607 CS-02 Before

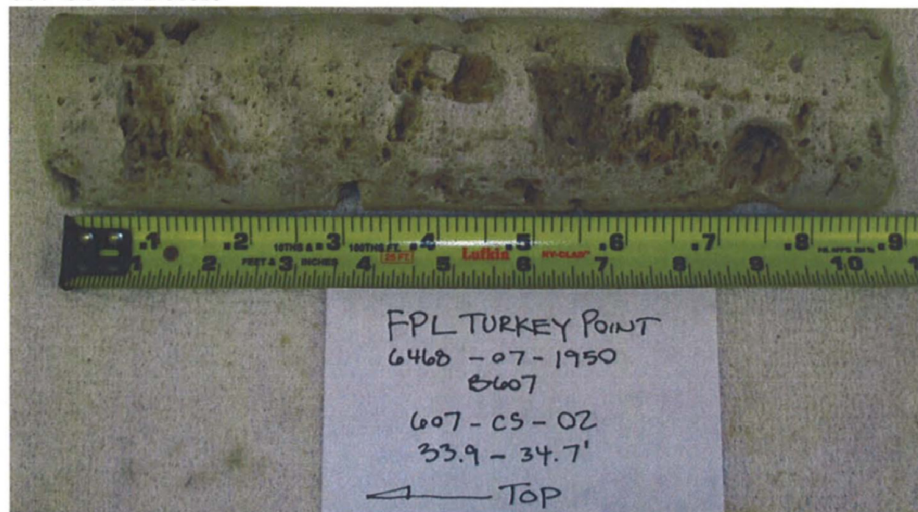
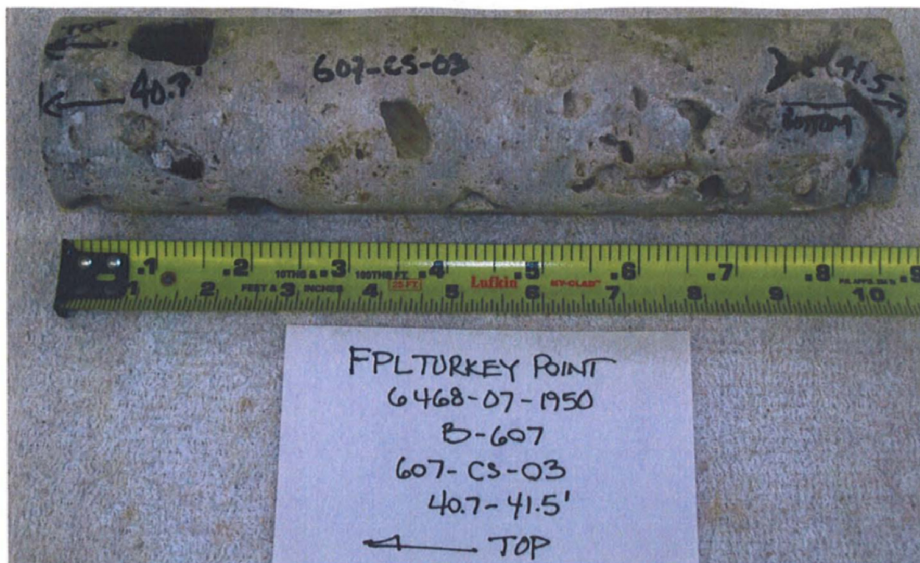
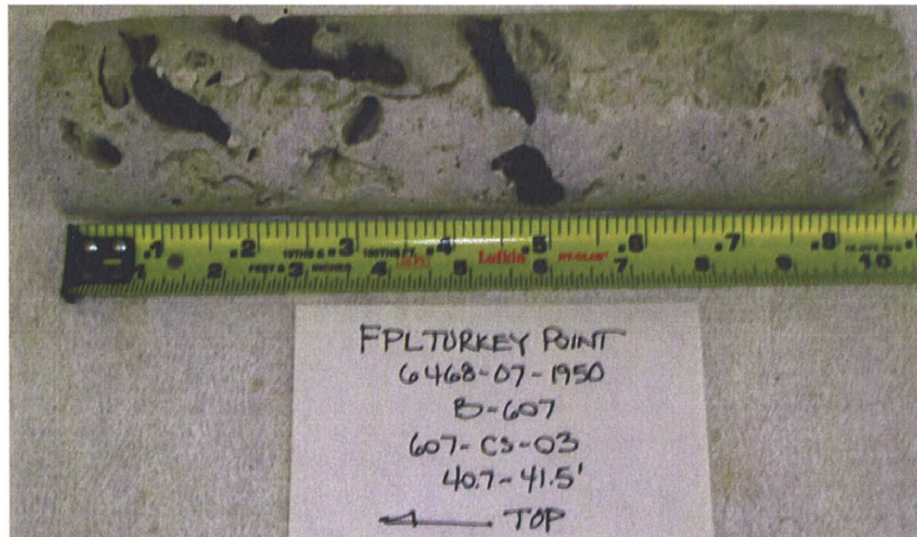
607 CS-02 Before

607 CS-02 After

607 CS-03 Before

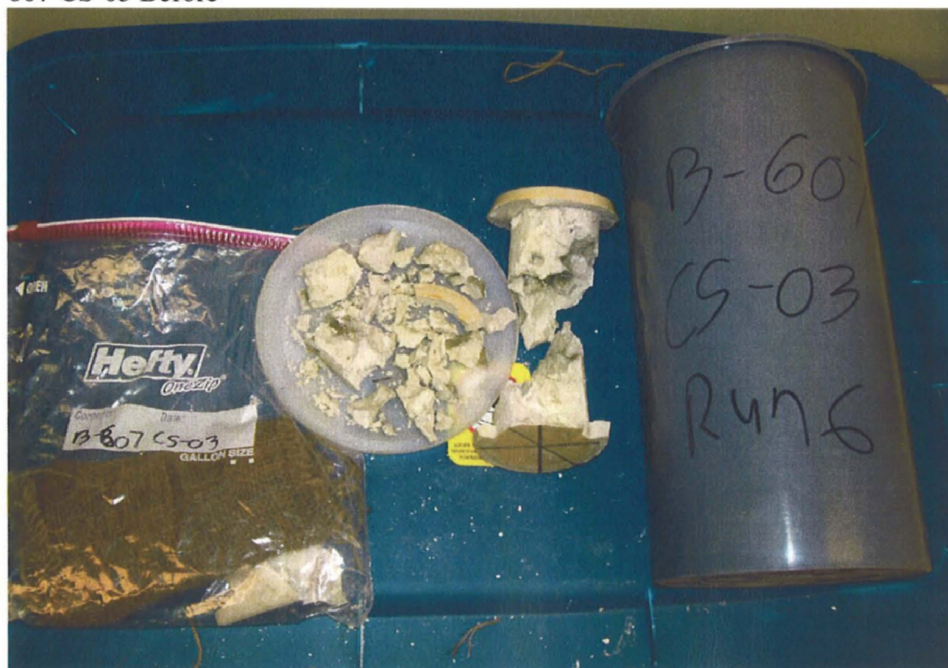
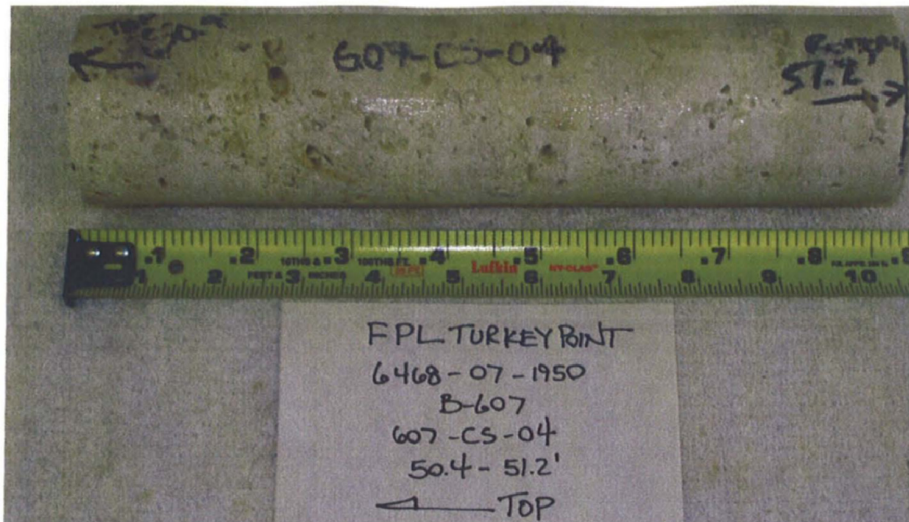
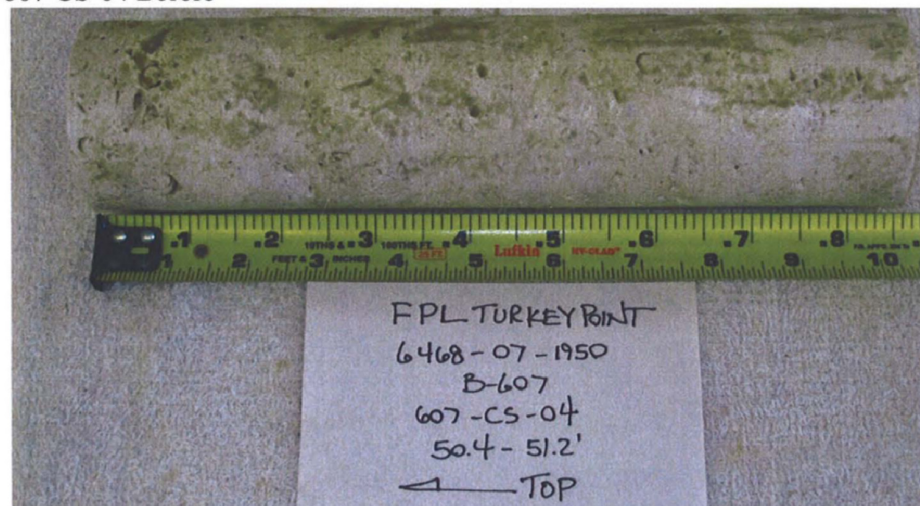
607 CS-03 Before

607 CS-03 After

607 CS-04 Before

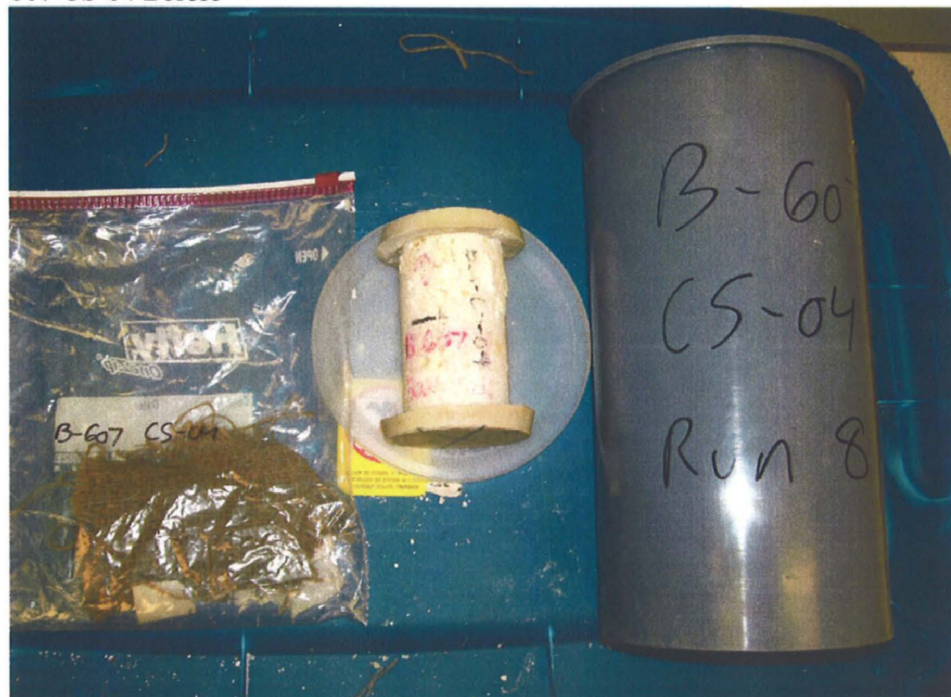
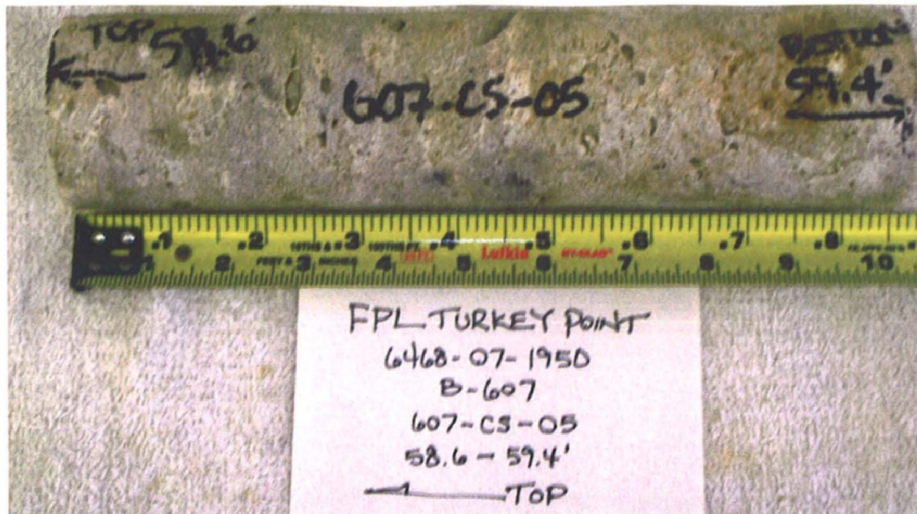
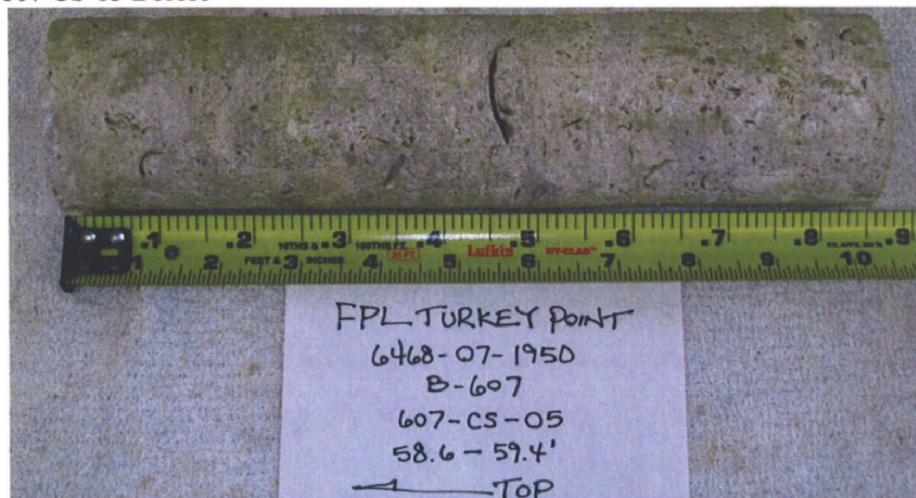
607 CS-04 Before

607 CS-04 After

607 CS-05 Before

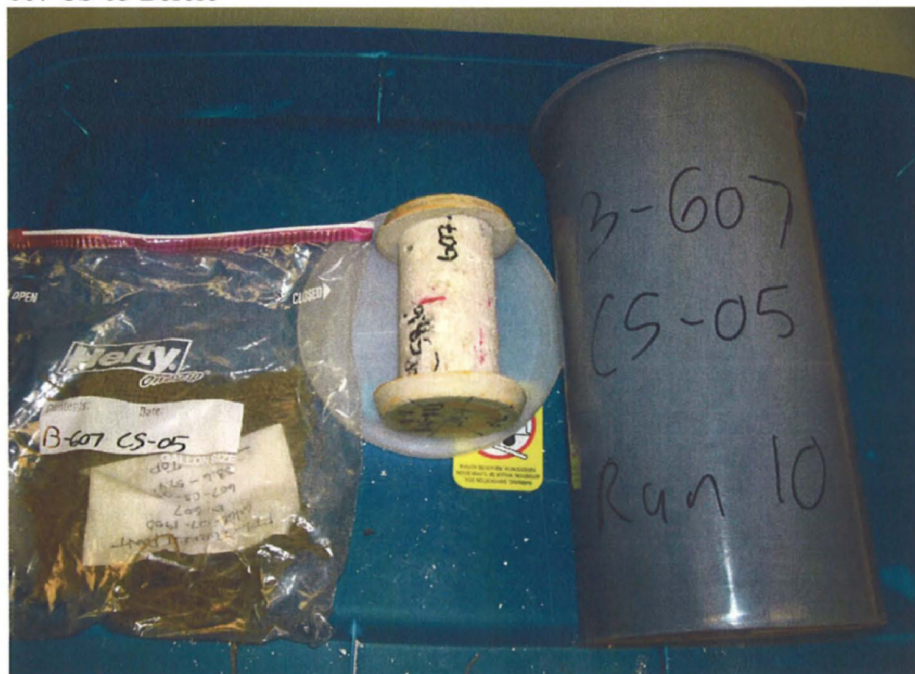
607 CS-05 Before

607 CS-05 After
